Developer Services
Southern Water
Sparrowgrove House
Sparrowgrove
Otterbourne
Hampshire
SO21 2SW

Proposal: Change of use from A1 (Shops) retail to C3a (Dwelling houses) residential. Integrate the retail area parlour shop into family living space at rear.

Site: 1 Orchard Crescent (Focus On Flora), Arundel Road, Walberton, BN18 0SD.

WA/50/18/PL

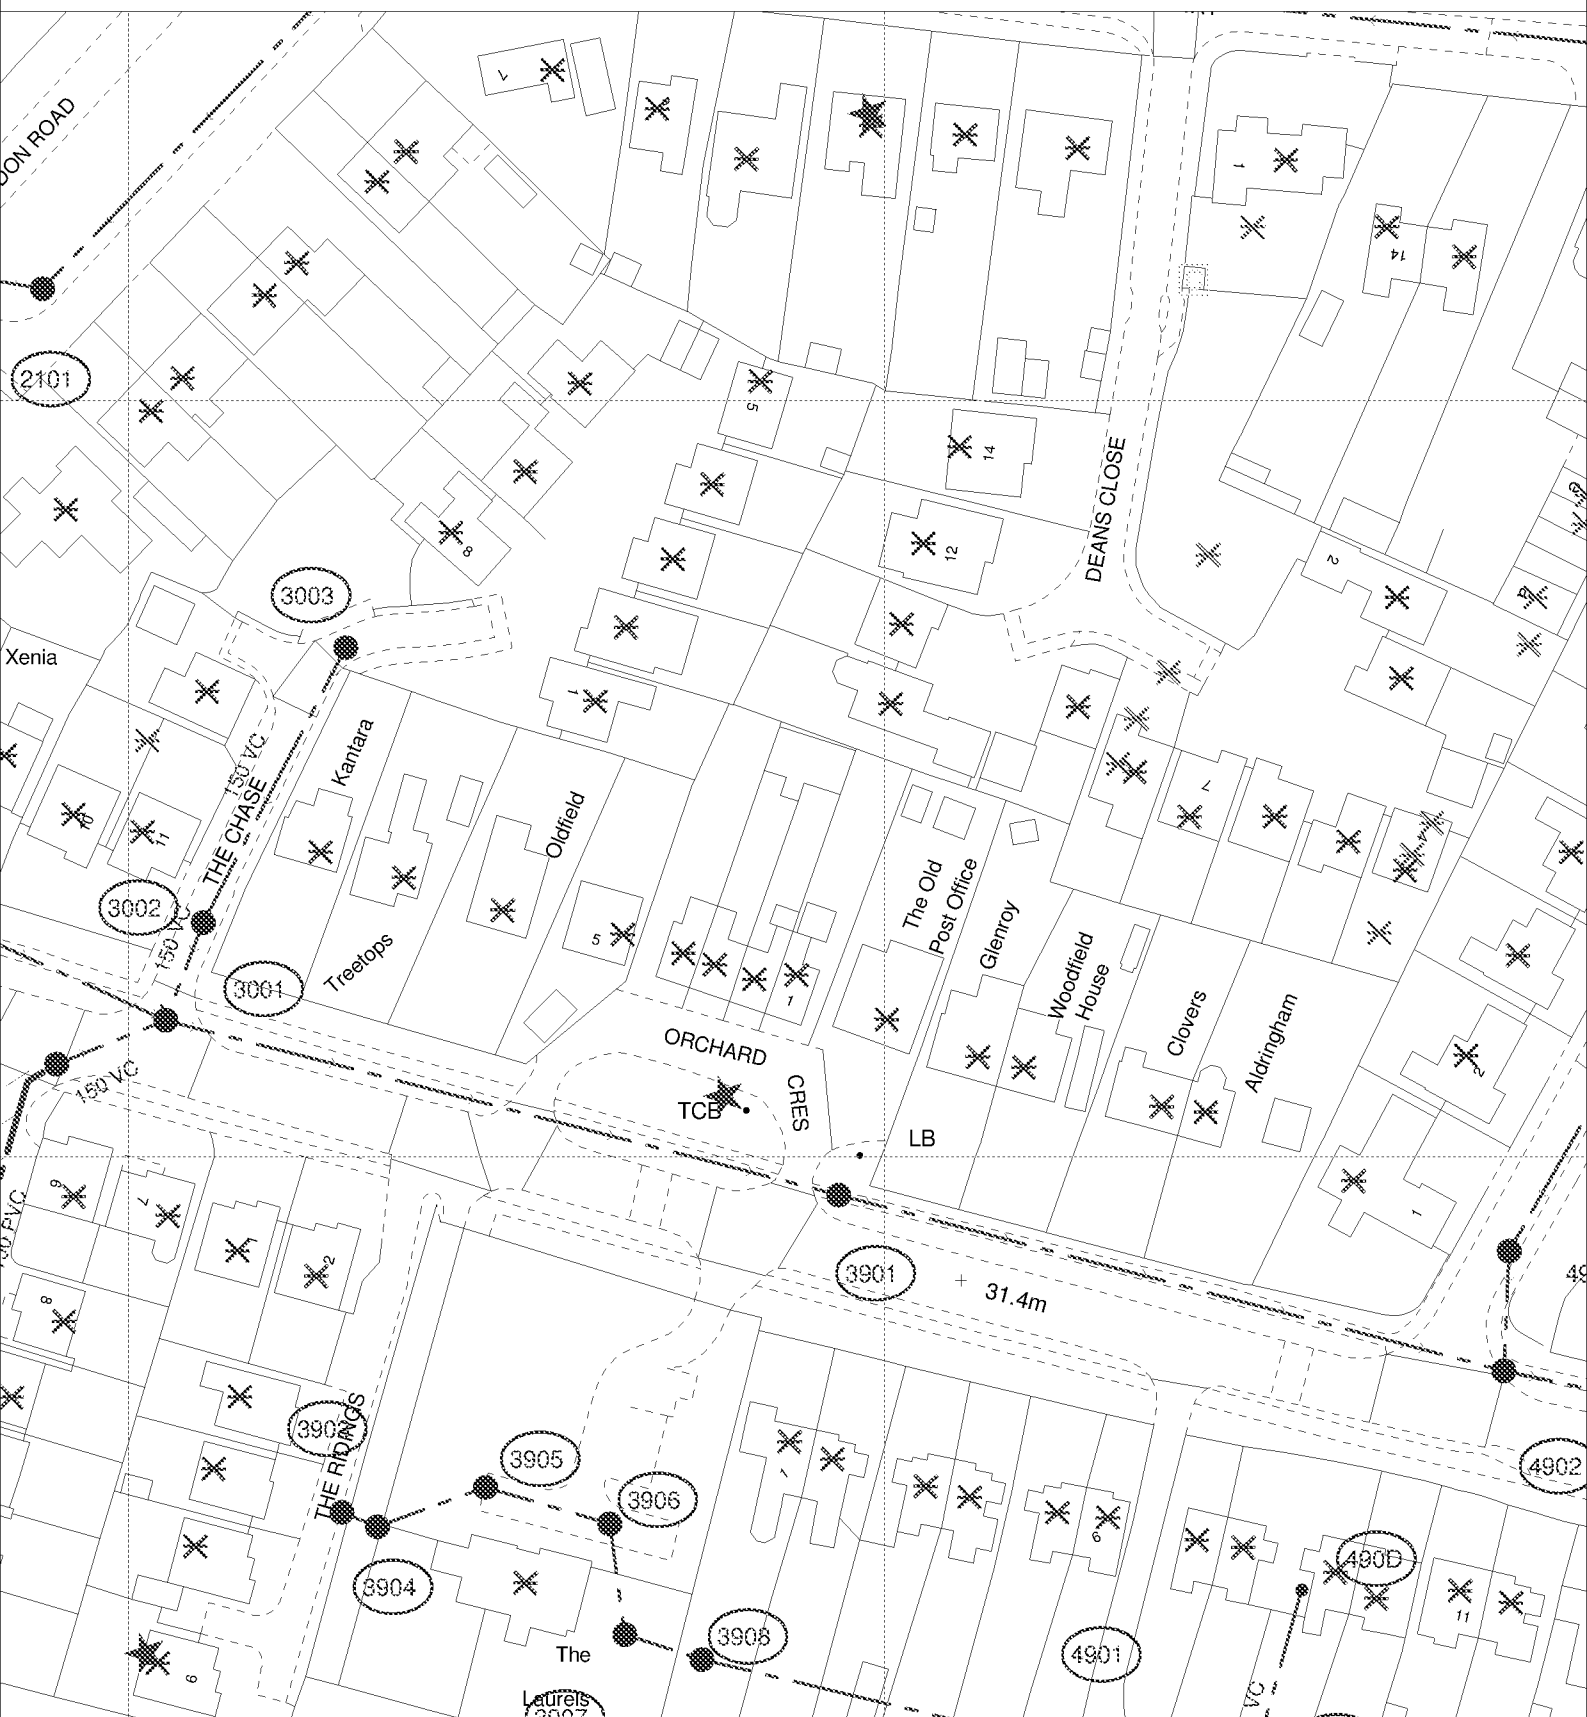
Due to surface water inundation issues in the Lidsey Catchment "The applicant is advised to adopt, where appropriate, the measures in the table "Practical measures to reduce the potential impacts of development".

Developer should look to protect the public sewerage system from inundation and infiltration, which contribute to flooding in unfavourable conditions.
